# MiniPOD Heat Sink

## Fin Height Reduction

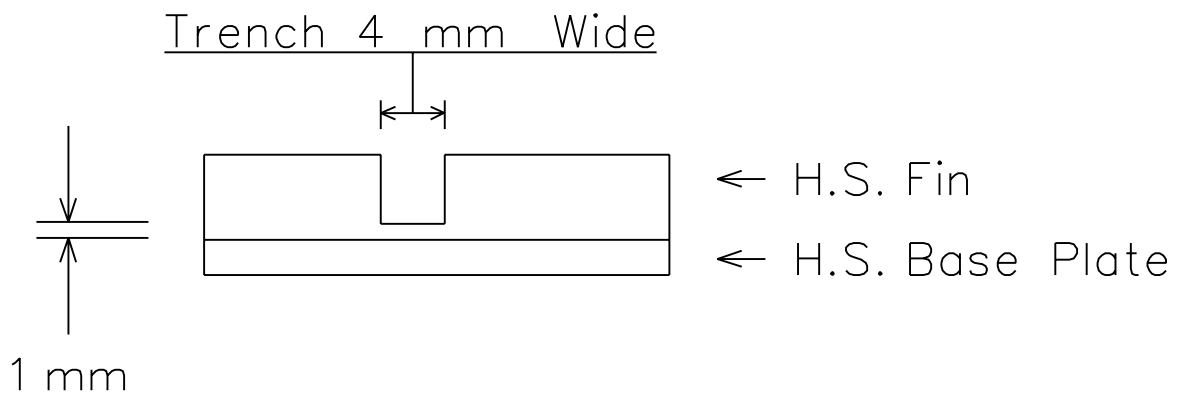
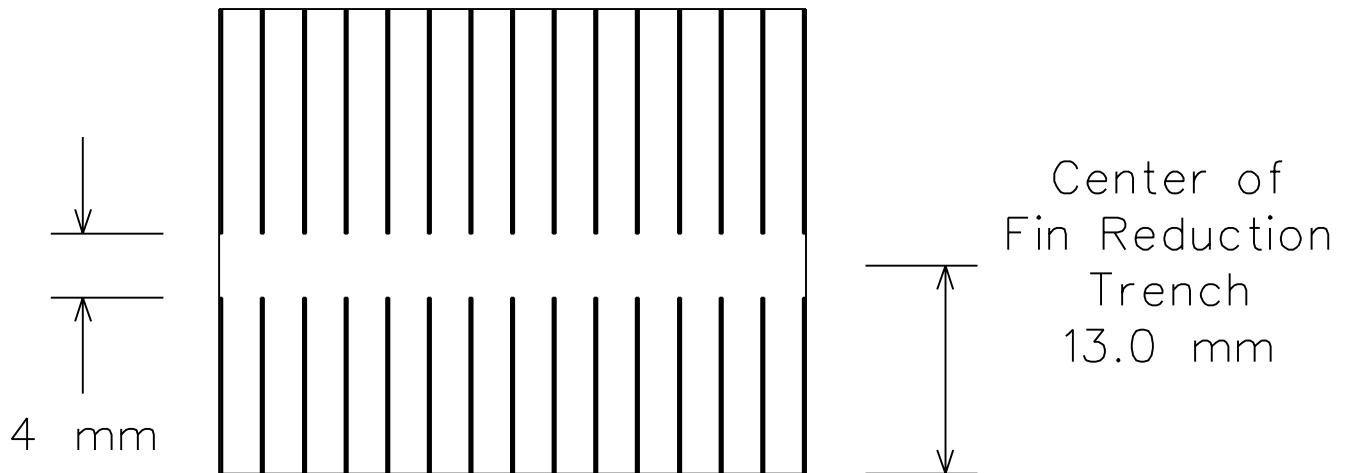
In a "trench" about 4.0 mm wide cut down the height of the fins so that they only reach about 1.0 mm above the base plate of the heat sink.
